Planning Application Ref: PL/25/0491

Address: 47 Parkside Road, Reading, RG30 2BT

Proposal: Erection of 1no. five-bedroom detached dwelling comprising two

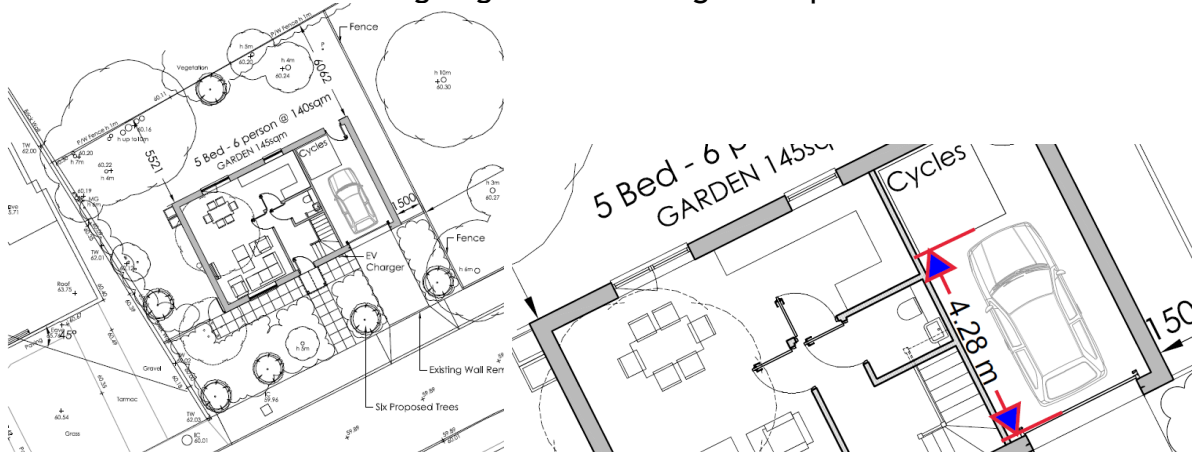
In accordance with the Councils current Parking Standards and Design SPD the new dwelling would require 2 off street parking spaces. Submitted floor plans illustrate a garage is to be provided, the recommended internal dimensions for a single garage as stated in the Councils current Parking Standards and Design SPD are 7m x 3m. While the width meets requirements the length falls short. The garage door opening into the garage further restricts the available space.

The site plan (extract below) illustrates cycle storage within the proposed garage which would further reduce the existing space, the reduced length of the garage can only be considered if cycle storage is moved into a secure garden shed located in the private amenity area and the direction of the garage door is changed to open outwards.
